CITY OF ALBUQUERQUE

**RE: Thurgood Subdivision
Grading & Drainage Plan
Engineer's Stamp Date: 08/16/20
Hydrology File: F14D078**

GRADING & DRAINAGE PLAN

THE
THURGOOD
DEVELOPMENT

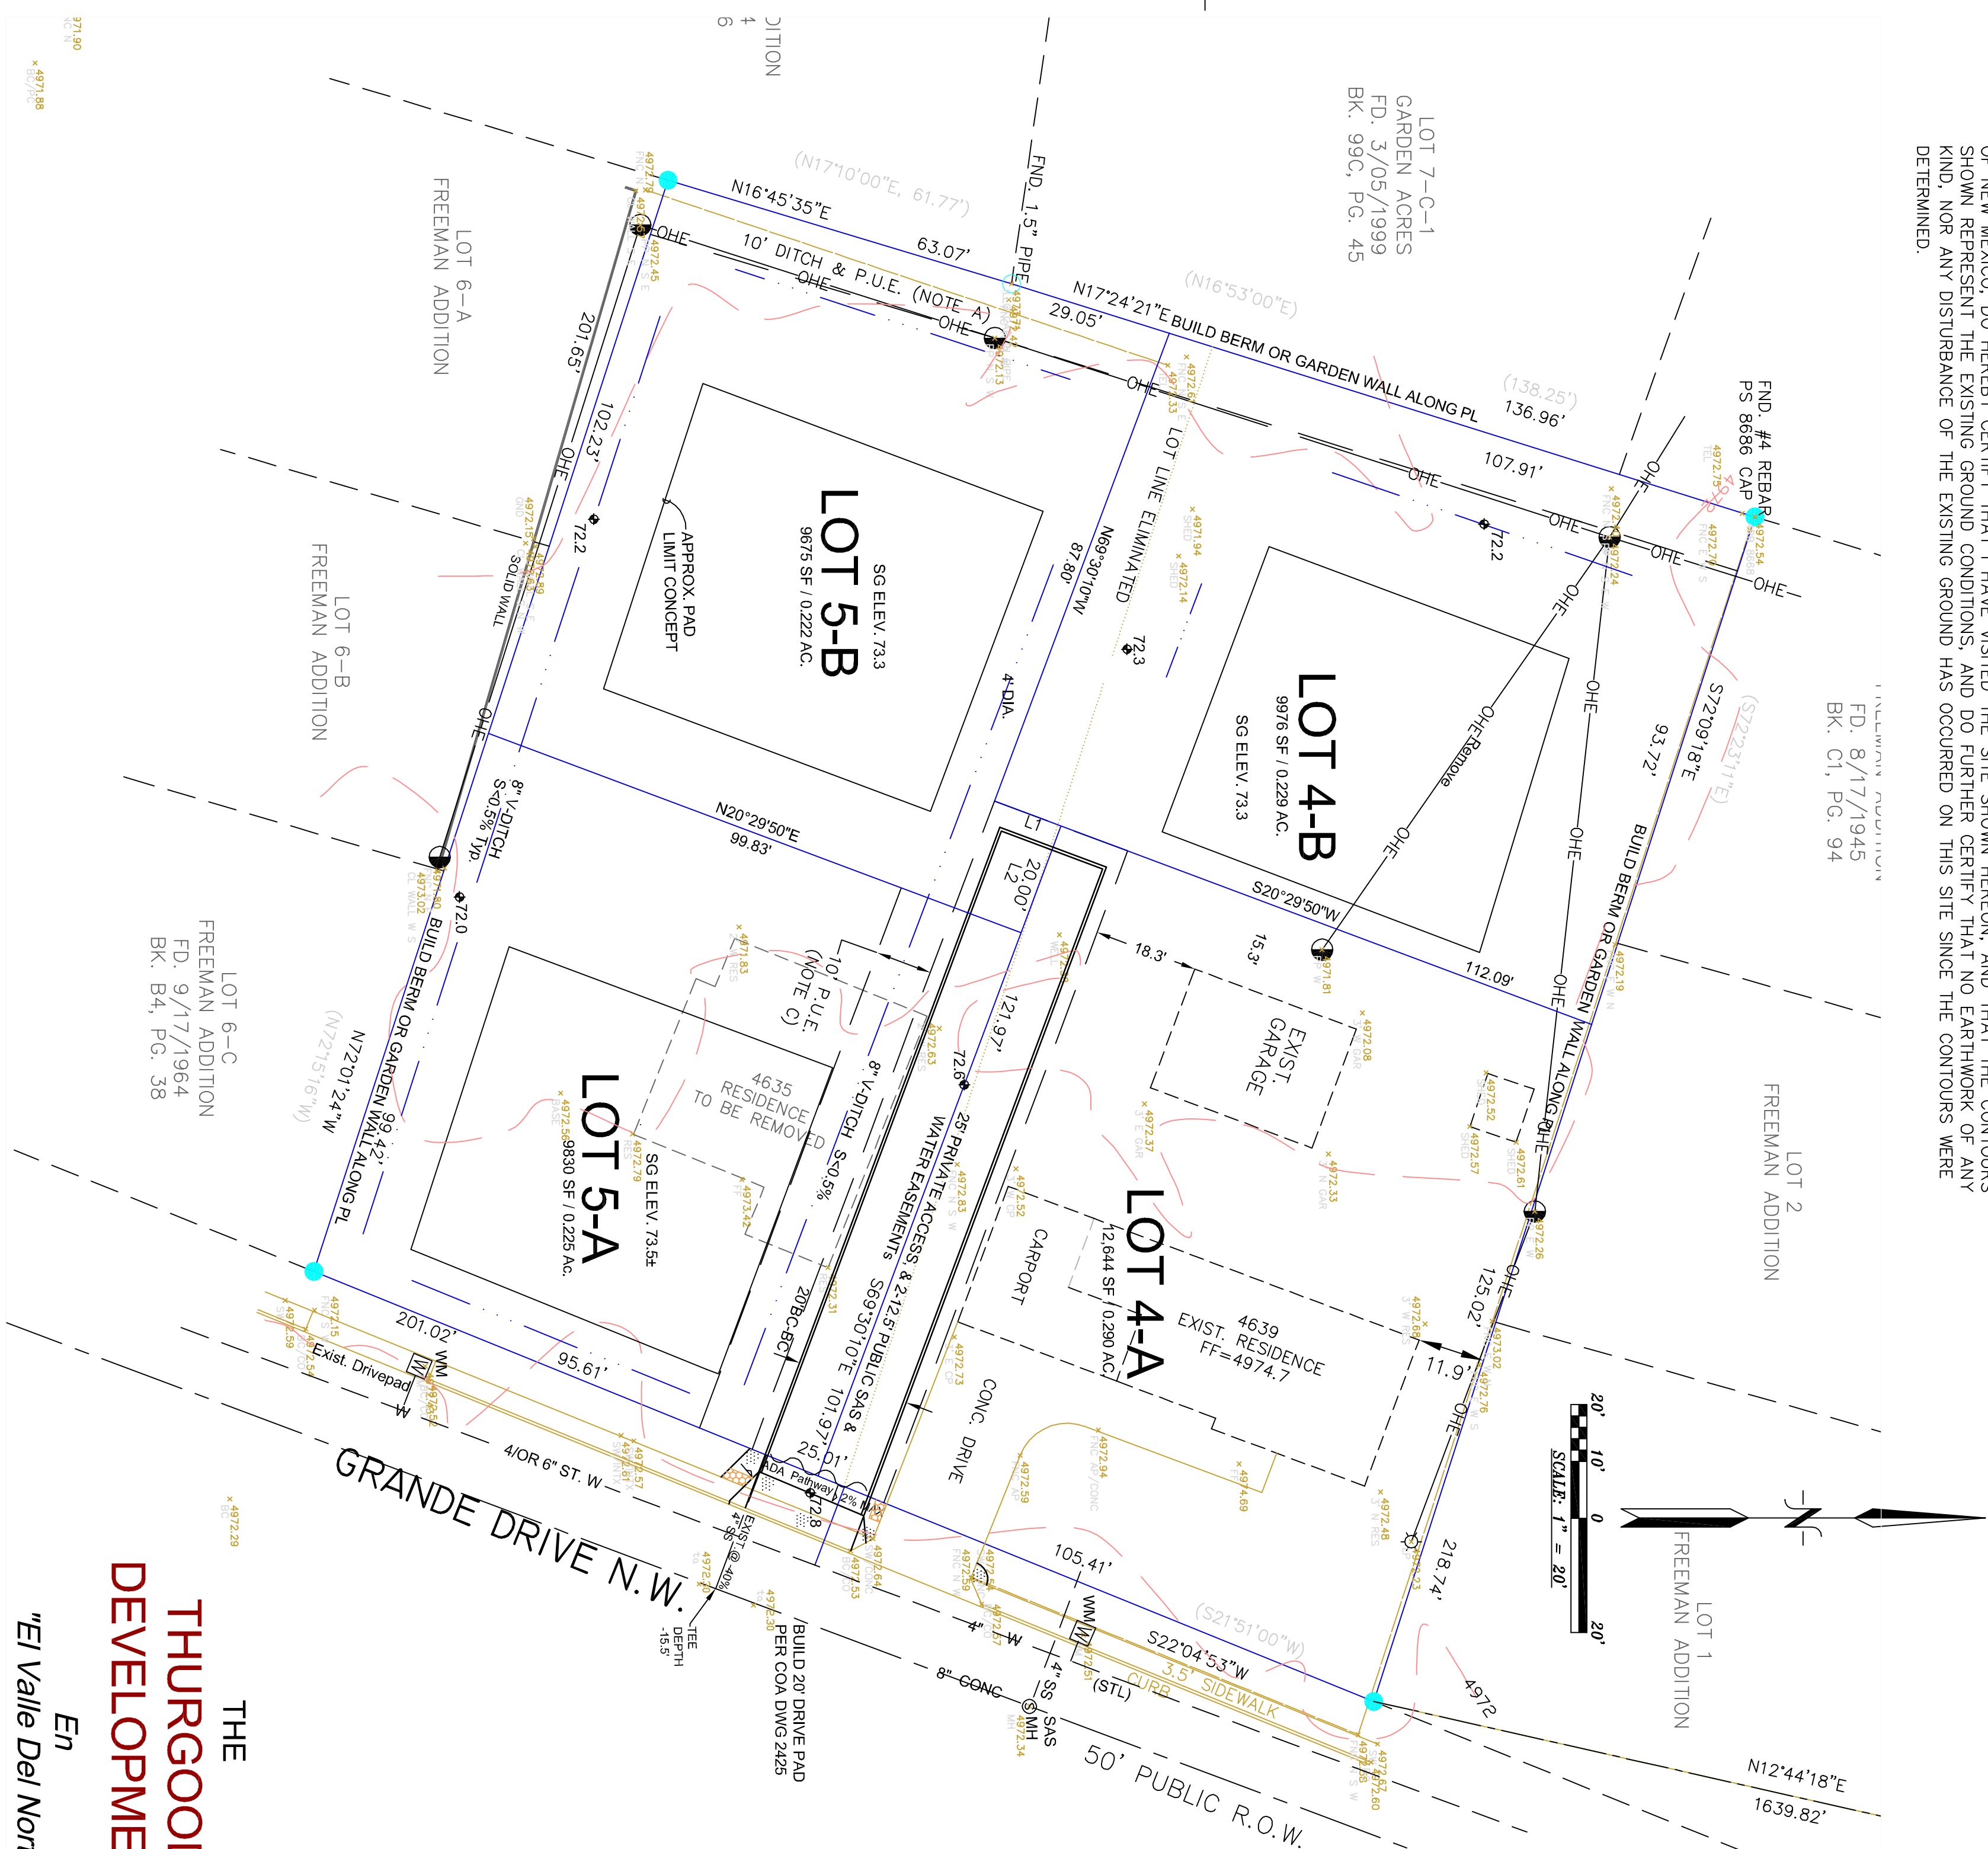
1. Please remove the reference to being compliance with the "Bernalillo County Flood Hazard Ordinance, 2009". Please replace this with "City of Albuquerque Development Process Manual (DPM) (signed 06/08/20) Chapter 6 - Drainage, Flood Control, and Erosion Control".

2. Since this site is in the Valley region, please follow Article 6-5 Valley Drainage Criteria of the DPM. Please refer to the update wording in the DPM. Also, please insure that the following conditions are be applied to the site some of these were not noted especially the location of each lots retention pond:
 - The maximum percent impervious of the lot and the contributing area may not be greater than 45%.
 - Pad elevation shall be a minimum of one (1) foot above the 100-year 10-day stormwater surface elevation.
 - The flow between the front yard and back yard cannot be obstructed. The stormwater must be allowed to equalize to the same level between the front yard and back yard.

- A permanent perimeter wall or barrier around the development is required to contain the 100-year 24-hour storm developed runoff.
- The high point of the street should be four inches above the 100 year 10-day stormwater surface elevation.
- Please show the required retention pond on each Lot along with the provided volume.

3. Please refer to the new DPM and please use the procedure for 40 acre and smaller basins as outlined in Development Process Manual (DPM) (signed 06/08/20) Article 6-2(a). All of your calculations need to be revised per these updated procedures.
